CITY OF COCONUT CREEK

DEVELOPMENT REVIEW COMMITTEE (DRC) REVIEW #3 – APRIL 24, 2024

PROJECT NAME:	MainStreet Block 11		
PROJECT NUMBER:	PZ-22080008		
LOCATION:	West Side of Lyons Road between Wiles Road and Sample Road		
APPLICANT/AGENT:	HSQ Group		
REVIEW/APPLICATION:	PMDD Site Plan		
DISCIPLINE	REVIEWER	EMAIL	TELEPHONE
DRC Chair Urban Design & Development	Liz Aguiar - Principal Planner	laguiar@coconutcreek.net	(954) 973-6756
Sustainability, Urban Design & Photometrics	Linda Whitman - Senior Planner	lwhitman@coconutcreek.net	(954) 973-6756
Urban Design & Signage	Natacha Josiah - Planner	njoshia@coconutcreek.net	(954) 973-6756
Transportation	Michael Righetti - Senior Project Manager	mrighetti@coconutcreek.net	(954) 973-6756
Building	Sean Flanagan - Deputy Building Official	sflanagan@coconutcreek.net	(954) 973-6750
Engineering	Eileen Cabrera - Senior Engineer	ecabrera@coconutcreek.net	(954) 973-6786
Fire	Ryan Banyas – Fire Marshal	rbanyas@coconutcreek.net	(954) 956-1563
Landscape	Scott Peavler - Landscape (consultant)	speavler@craventhompson.com	(954) 739-6400

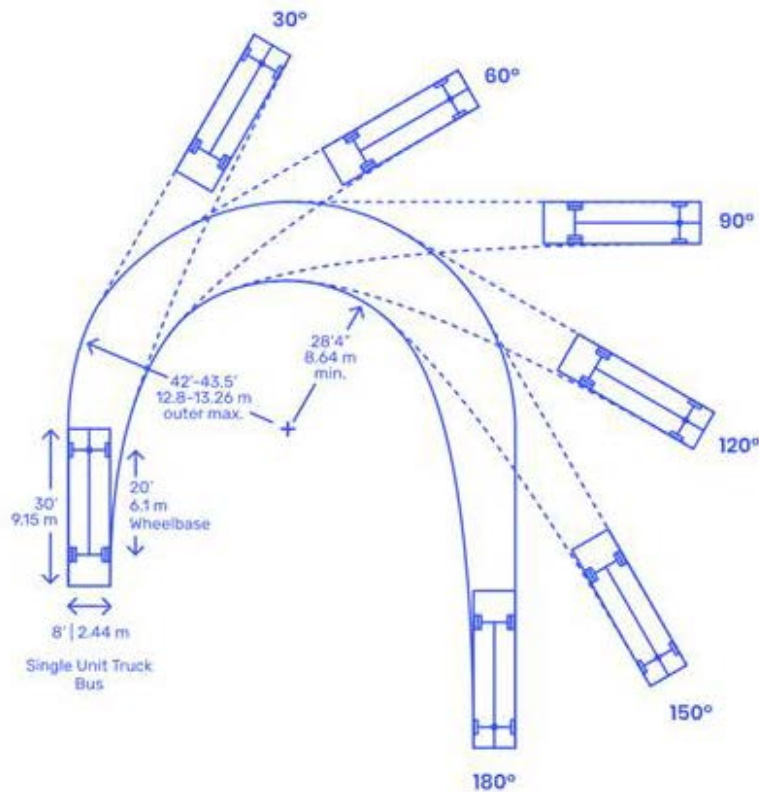
1. Fire department access roads shall be provided such that any portion of the facility or any portion of an exterior wall of the first story of the building is located not more than 150 ft. from the fire department access roads as measured by an approved route around the exterior of the building or facility (NFPA 1-18.2.3.2.2). Shall be permitted to increase to 450 feet if the building is equipped with an approved automatic sprinkler system.

The Fire Truck Route Plan shall show turning radius dimensions.

A vehicle's turning circle is the radius (or diameter) measured by the outer wheels of the vehicle while making a complete turn, without any physical conflicts (i.e. curbs, light poles, fire hydrants, etc.);
